Subject: Comments on Recently Received Documents Pertaining to
Seattle Tacoma International Airport Project
Third Runway – Low Flow Analysis

GeoSyntec Consultants (GeoSyntec) has been retained on behalf of the Airport Communities Coalition (ACC) to provide a technical review of investigation, analysis and design relating to geotechnical and hydrogeological elements of the proposed Third Runway Expansion Project at the Seattle Tacoma International Airport. GeoSyntec has previously commented on seismic and geotechnical aspects of the embankment fill and Mechanically Stabilized Earth Wall. In my October 2001 declaration in support of ACC's motion for stay, I raised numerous concerns relating to the Port's Low Flow Analysis. This letter presents an expansion on the issues raised in the declaration based largely on review of the November 27, 2001 report by Pacific Groundwater Group (PGG) titled "Port of Seattle - Sea-Tac Third Runway - Embankment Fill Modeling in Support of Low Streamflow Analysis."

Figure 5: Moisture Content Variation Over Time for Cross Section 2
Using Hart Crowser Group 3 Embankment Fill Properties

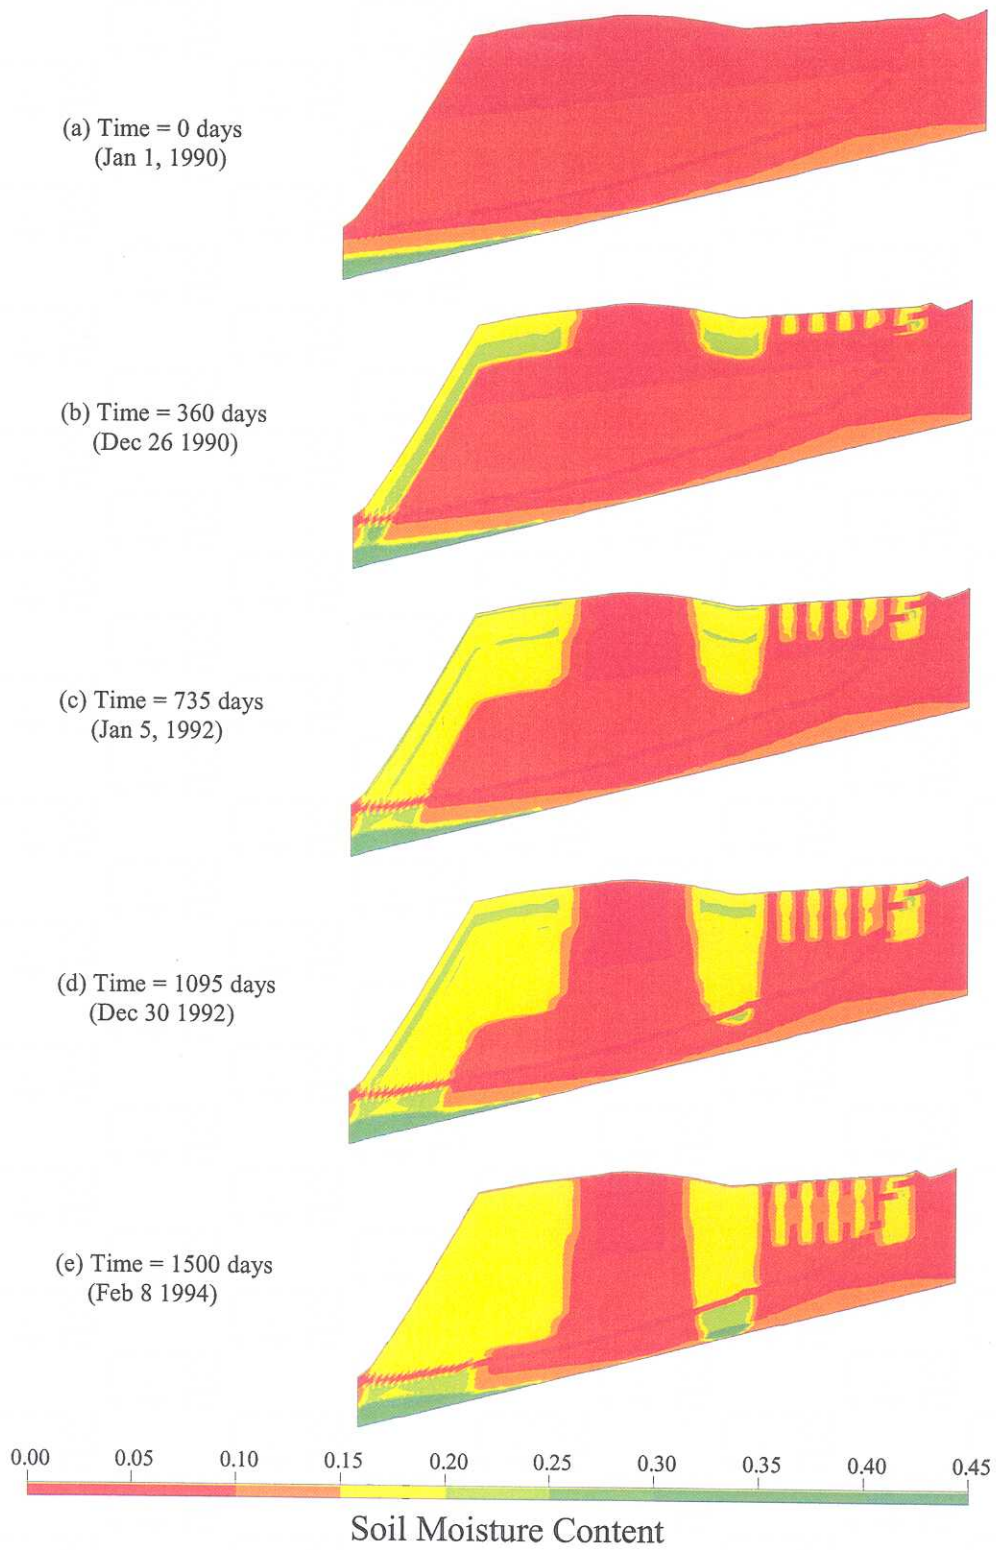
Figure 5a presents a schematic of the Hydrus model cross-section being used by GeoSyntec, which is based on PGG's section 2, with an embankment fill height of up to 110 ft. The embankment fill, the drainage layer, the outwash layer, and the underlying till are all being modeled within Hydrus. The model is being run using approximately four years of daily precipitation data (January 1990 through February 1995) from the SeaTac airport. No runoff or evapotranspiration calculation has been made, so all precipitation is assumed to enter the embankment.

Figures 5a through 5e present preliminary results using the Hart Crowser Group 3 fill properties described in Comment 2. The lighter colored front that progresses downward over time represents the propagation of the infiltrating precipitation. It is clear that the water infiltrating near the face of the slope, which has a shorter travel path to the drainage layer has already begun to reach the drain and then the creek by approximately 1 year after the modeling begins (Figure 5b). However, the flow under the thick majority of the embankment is only beginning to reach the drainage layer between 3 and 4 years (Figures

5d and 5e). With the uniform soil profile assumption relied upon by the Port, there is only slight evidence of horizontal flow of water, although Figures 5b through 5e show a gradual narrowing of the dark colored band of dry soil beneath the runway, indicating that moisture is gradually working its way laterally. This effect can also be seen in the flow of water between the filter strips on the right side of the model. The significance of this lateral flow component is that water will travel within the embankment fill for longer periods of time prior to reaching the drain and the creeks than with analyses limited to vertical flow only. The Port, using their simplified analyses, has reported none of these trends.

Figure 6: Comparison of 1-Dimensional versus 2-Dimensional Flow in Uniform Fill Columns (2.5 ft thick) with Port Properties

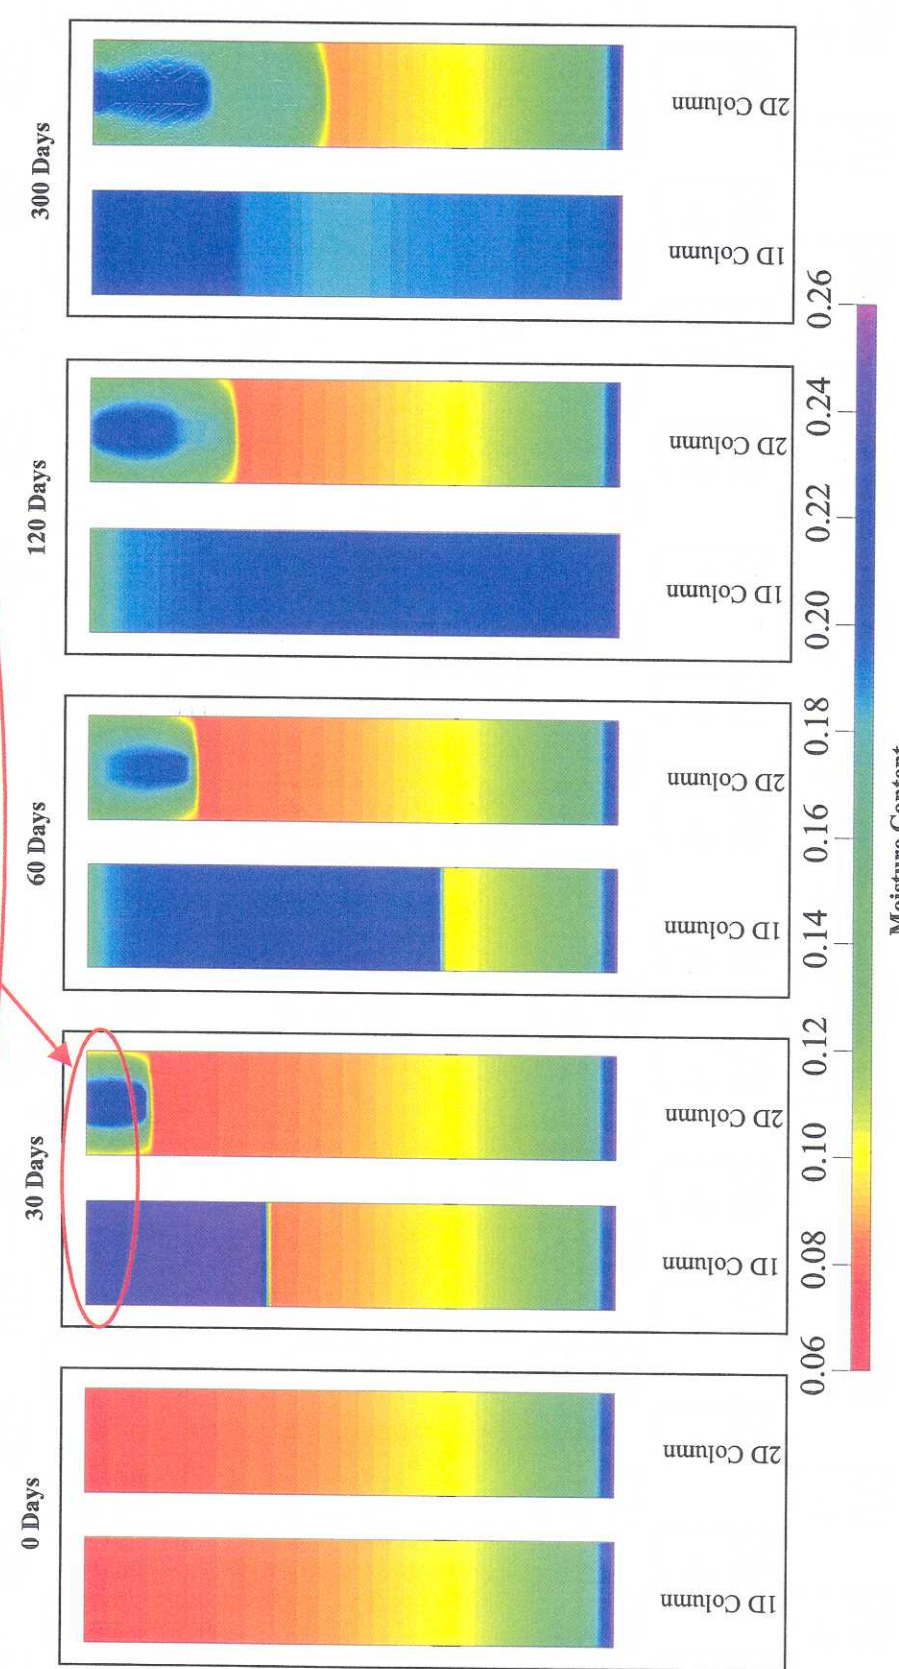
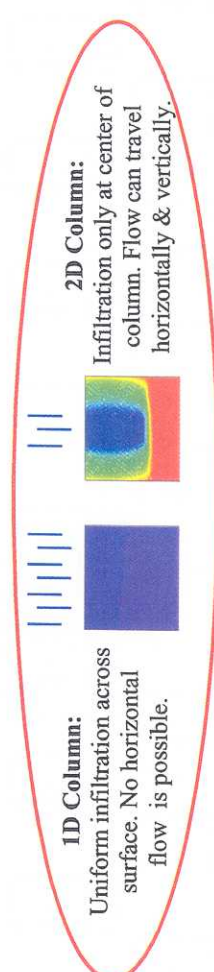
To demonstrate the impact of horizontal flow on the travel time of water flowing through the embankment, two sets of analyses were performed using the Port's soil properties as shown on Figure 6. Two 25 ft thick fill columns were modeled in Hydrus. In the 1-Dimensional (1D) column, water infiltrating at the top of the column travels downward vertically, without an opportunity for any horizontal flow (same analysis as described in Comment 2). In the 2-Dimensional (2D) column, water was applied over the middle 2/5th of the column only, but once the water entered the soil column, it was allowed to travel both vertically and horizontally. This 2-Dimensional scenario is representative of precipitation adjacent to the runway or filter strips (as seen on Figure 5), where water landing directly on the fill surface can pass directly into the embankment, but water landing on the impermeable runway or filter strips cannot.

Comparison of the 1D and 2D columns on Figure 6 makes the impact of horizontal flow immediately apparent. After 30 days, while flow in the 1D column has had nowhere to go but downwards (represented by the advancing dark colored wetting front), flow in the 2D column has traveled downwards and laterally (represented by the dark colored center and lighter colored bands spreading outwards both in front and on the sides of the wetting front). By 60 days, the wetting front in the 1D column has traveled approximately two thirds of the distance to the drain, while the 2D column wetting front has only progressed a quarter of the distance to the drain. This trend continues throughout the analysis, as the 1D column can only send water downwards, while the 2D column continues to allow water to fill in underneath the impermeable regions on either side of the entry point. Clearly, without incorporating this effect into their analysis, the Port is overpredicting the rate at which water flows through the fill, and therefore their estimates of the time at which flows will arrive at the creek will not be representative.
